PRIVATE SEWAGE SYSTEM
INSPECTION REPORT for Dunn County

Property Address/City	N6164 370th St.
Town of	Menomonie
Legal	SE-SE 17 28-13
Subdivision	
CSM #	Lot. 2 CSM #1117
Sanitary permit #	651268
State Plan ID #	PWTS-082301755-C
Parcel tax #	1701622813174400005
Computer #

CONDITIONAL APPROVAL

SITE:
RON WELSCH
N6160 370TH ST
MENOMONIE, WI 54751
SE1/4 SE1/4 S17 T2813W

ELEVATION DATA

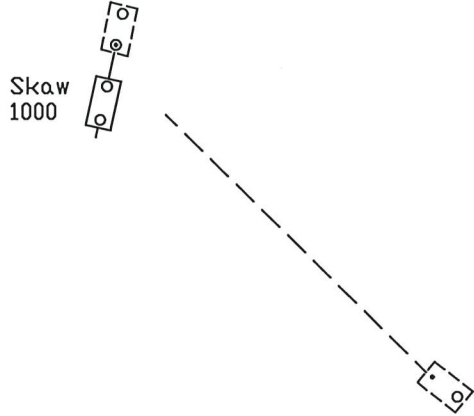
-New Mound flagged by Soil Tester. Contour didn't match design elevation. Used flagged contour and shifted system elevation and lateral elevation accordingly.
 -Existing Mound contour didn't match paperwork. Plumber used pump pad on old inspection report and bottom of system to install mound with 1ft of sand.
 -Existing Simtech Filter. Adding Lifetime filter to new septic tank. Existing forcemain buried.
 11/13/2023-New Mound
 11/14/2023-Existing Mound & Tank
 Date

Recore existing mound and adding 2nd mound and pump tank to serve 5 bedroom house and business with 2 employees
 *Easement filed to allow Mounds partially on southern parcel.

SITE PLAN 1" = 40'

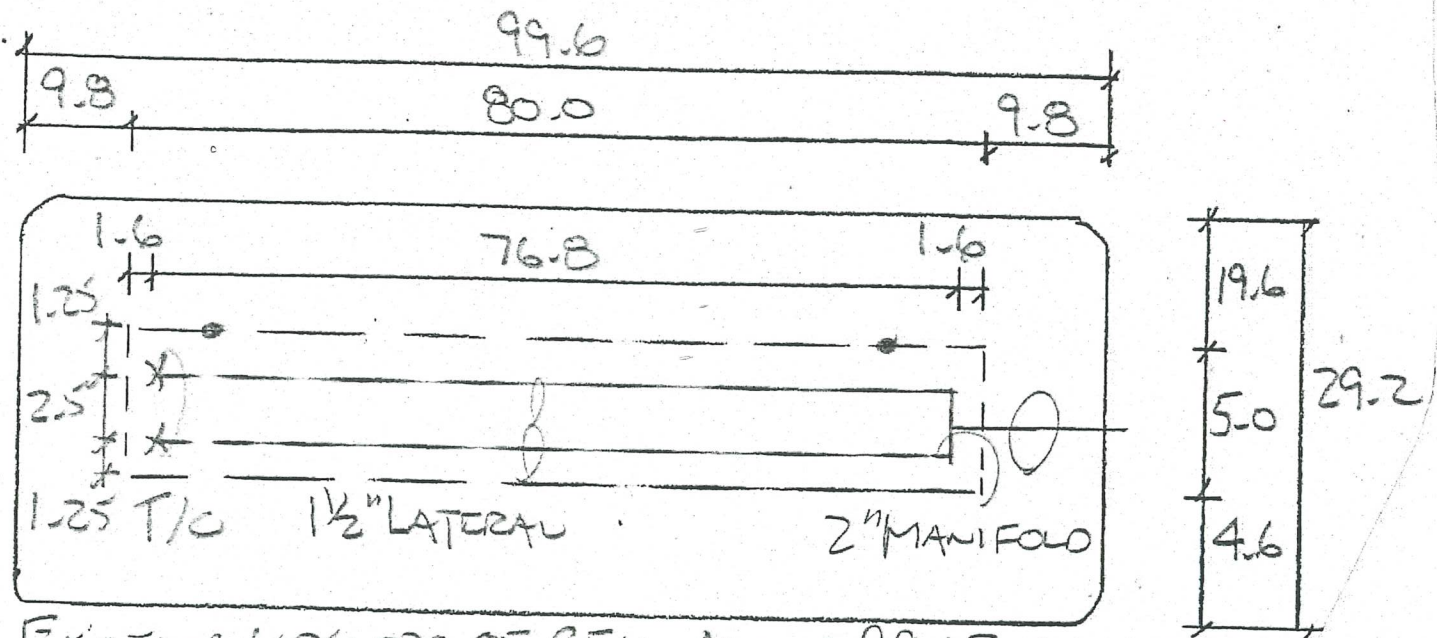
The plans do not have detailed instructions for the replacement of the existing failing mound system dispersal component. The following must be completed in addition to any comments made from the County inspector:

REBUILD EXISTING MOUND. REMOVE CAP, ROCK, LATERALS,
 AND BIOMAT. REPLACE BIOMAT WITH ASTM C33 SAND
 TO 100.62 ELEVATION. ADD DOWNSLOPE IF NECESSARY
 UPSLOPE AND END SLOPES TO REMAIN
 DISPOSE ROCK, BIOMAT, PIPE PER DNR

- Remove excess/overgrown vegetation from mound, mow and remove clippings. Remove and stockpile topsoil from the mound system. Remove cap dirt and stockpile.

- Pump out any standing wastewater through observation pipes.
- Permit dispersal area to dry out.
- Pump out septic and dose tanks.
- Remove aggregate from absorption area(s) and dispose of in approved manner. (This material cannot be re-used.)

- Remove distribution pipes and observation pipes. Dispose of properly.
- Remove end cap markers if present and dispose of properly.
- Remove clogged sand plus an additional 3 inches of clean sand and dispose of properly. (Sand with observable particulate matter cannot be re-used.)

- Sample remaining sand at several locations and have it analyzed for particle size. If the sand does not meet ASTM Specification C-33 for fine aggregate, it must be removed down to the natural soil.

- Install replacement mound system using procedure outlined in the approved mound system component manual.

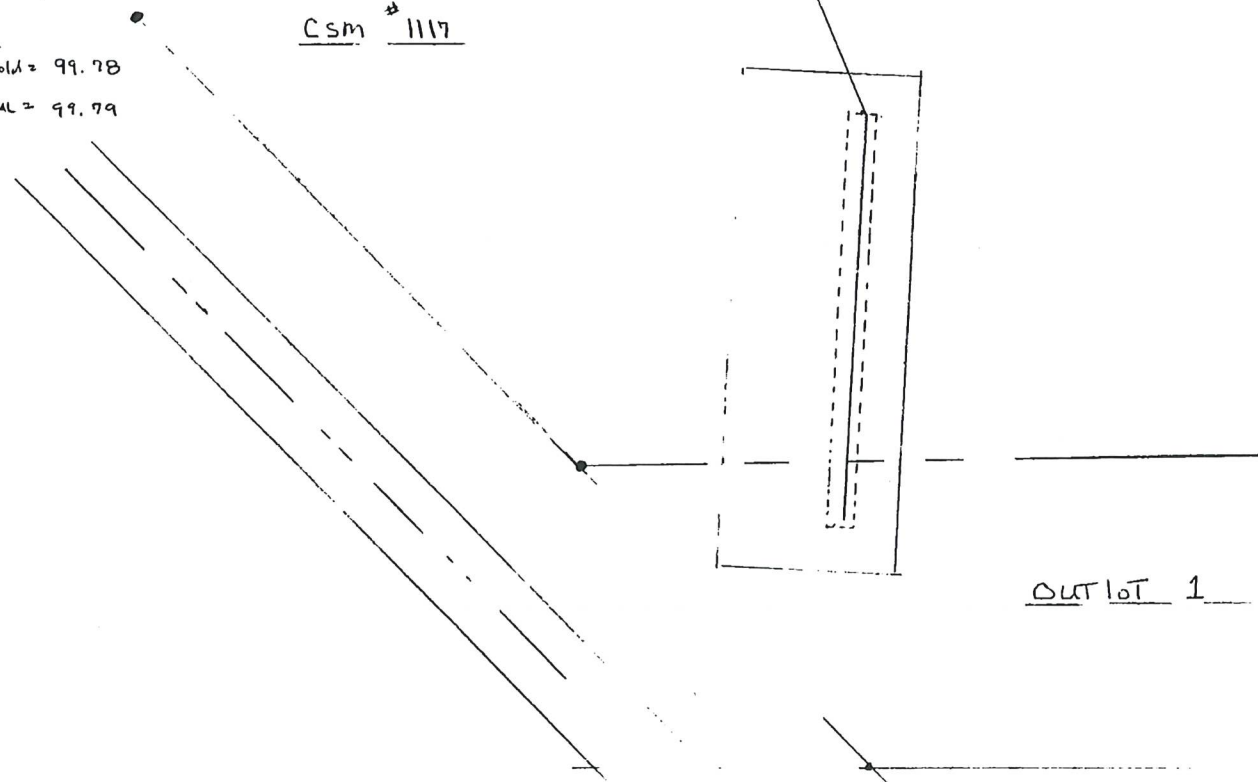
- * Well not located.
- **Mound system encroachment into Outlot 1

System Cross Section

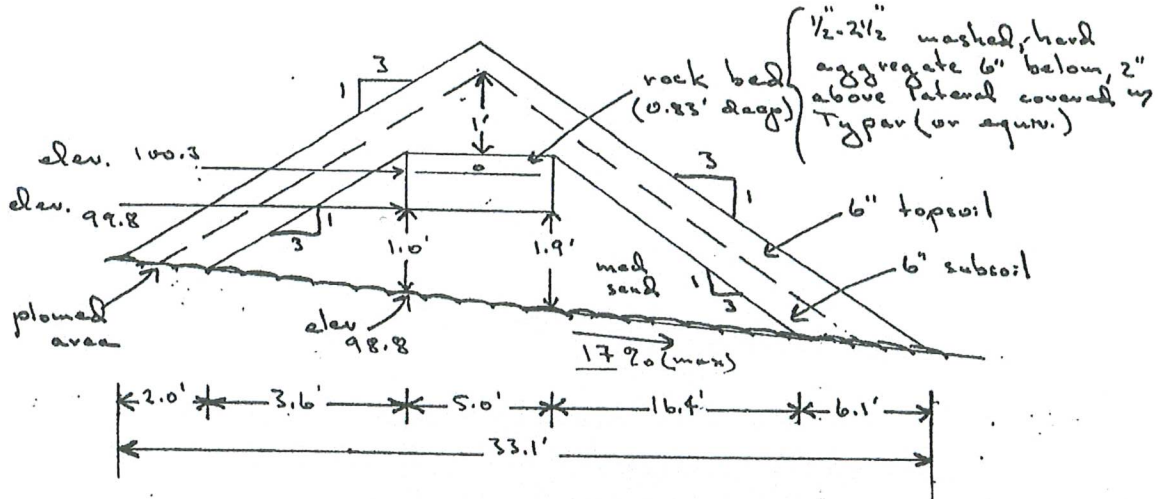
Note: rock bed
 *Upslope "J" to be 6.3'
 min. in area of 11% slope.
